SAFETY EVALUATION BY THE OFFICE OF NUCLEAR REACTOR REGULATION

RELATED TO AMENDMENT NO. 10

UNIVERSITY OF MARYLAND

MARYLAND UNIVERSITY TRAINING REACTOR

Figure 2. MUTR Current Core Design

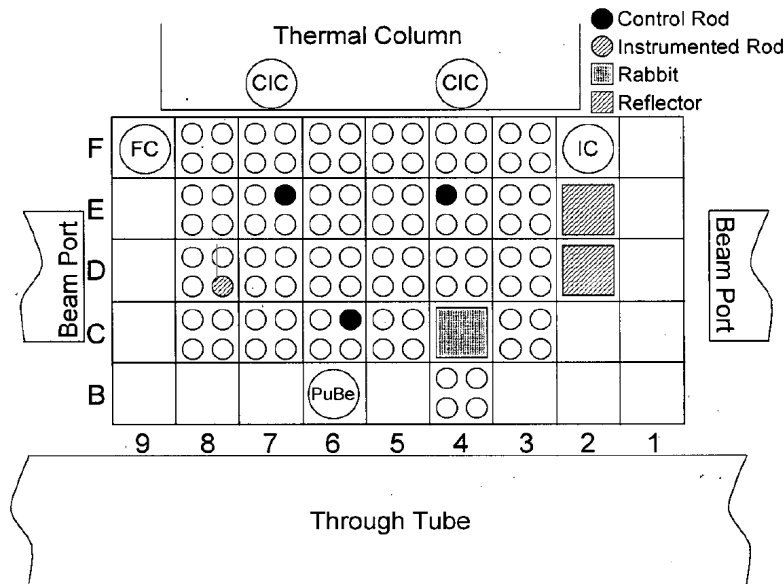
The NRC staff evaluated the proposed TS 1.3 definition of "Core Configuration," using the guidance in ANSI/ANS-15.1-2007, Section 1.3, "Definitions," and NUREG-1537, Part 1, Chapter 14. Figure 2, "MUTR Current Core Design," in UMD's RAI response for license renewal, dated February 2, 2011 (ADAMS Accession No. ML110350175), which is included in Section 3.1.1 of this SE, shows the current core configuration for the MUTR. The core grid plate

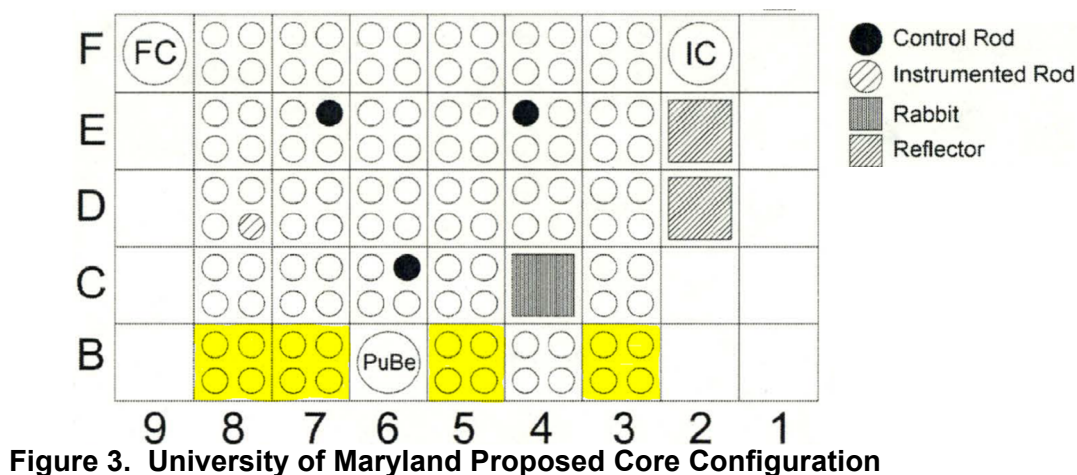
In the LAR, as supplemented by UMD's response to RAI-6 by letter dated January 13, 2020, UMD proposes to visually inspect at least 4 Four-Element Fuel Bundles from rows B and C on an annual basis, not to exceed 15 months and to visually inspect all Four-Element Fuel Bundles in rows B and C every 2 years. The licensee stated that this visual inspection would include the proposed addition of 16 elements configured into 4 Four-Element Fuel Bundles to the core. The licensee further stated that proposed TS 4.1, Specification 4, does not require the visual inspection of grid position C6 since this Three-Element Fuel Bundle is not readily accessible without an excessive risk of damage to the fuel as a result of movement. The Three-Element Fuel Bundle contains a “control rod guide tube” and “control rod,” which are defined in TS 1.3 as follows:

The NRC staff finds that visual inspection of grid plate position C6 is not needed because of the potential risk of damage to the control rod, guide tube, and fuel elements. UMD proposes to insert the additional 4 Four-Element Fuel Bundles into row B, positions B8, B7, B5, and B3 of the core grid plate as highlighted in Figure 3, "University of Maryland Proposed Core Configuration." The NRC staff finds that visually inspecting of 4 Four-Element Fuel Bundles annually and all Four-Element Fuel Bundles in a 2-year period from rows B and C accounts for approximately 15 to 18 percent, respectively, of the proposed core. The portion of TS 4.1, Specification 4 that requires inspection of the entire core if a damaged element is identified, remains unchanged.

Figure 4. MUTR Proposed Core Design

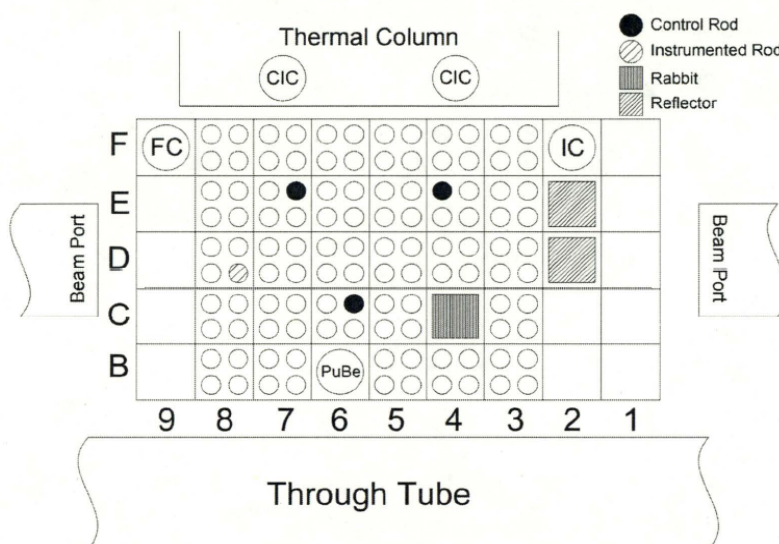
UMD proposed to insert the 16 elements grouped as 4 Four-Element Fuel Bundles in core grid plate positions B8, B7, B5, and B3 positions within the fueled core region. Based on its review of the LAR, as supplemented by UMD's response to RAI-9, the NRC staff finds that the proposed addition of the 4 Four-Element Fuel Bundles, is acceptable because the calculated excess reactivity, the SDM, the thermal-hydraulics evaluation, and the IFE location in the core, result in a core configuration that is: (1) a rectangular arrangement with equal sides (i.e., square) and that (2) contains no vacant internal positions within the fueled core region. In addition, the staff finds that this core configuration can be accurately described as "a close-packed" instead of a "rectangular" array because the described arrangement eliminates vacant grid positions in the core to minimize the possibility of an inadvertent reactivity addition into the core that could result in a significant power excursion, and supports operational flexibility by allowing adjustments in the core as long as UMD maintains a closely packed core configuration. Therefore, the NRC staff finds that revising TS 1.3 to describe the core arrangement as a closely packed configuration is acceptable.

UMD proposed to add the words "TRIGA fuel elements assembled into THREE or FOUR ELEMENT FUEL BUNDLES" describing the fuel bundles in the core. ANSI/ANS-15.1-2007, Section 1.3, states that core configuration includes the type of fuel elements occupying the core grid. The MUTR is presently fueled with stainless steel clad TRIGA-type elements assembled into Three-Element or Four-Element Fuel Bundles. UMD states in the LAR that the fuel elements will be assembled into Four-Element Fuel Bundles. The NRC staff finds that, because the proposed additional fuel elements will be assembled into Four-Element Bundles and the existing core only contains TRIGA fuel elements assembled into Three-Element and Four-Element Fuel Bundles, adding "TRIGA fuel elements assembled into THREE or FOUR ELEMENT FUEL BUNDLES" accurately describes the proposed core configuration shown in Figure 4 of this SE.

UMD proposed to delete “rectangular 4 x 6 configuration” and add “close-packed array” describing the arrangement of the fuel bundles in the core. Additionally, UMD proposed to delete “one bundle,” which specifies the number of fuel bundles displaced by the in-core pneumatic experimental system and to specify other core components that displace fuel bundles by adding “bundles” and “PuBe source, neutron detectors, and graphite reflectors” to describe normal core configuration. UMD proposes to add Four-Element Fuel Bundles to grid plate positions B8, B7, B5, and B3 as shown in Figure 4 of this SE.
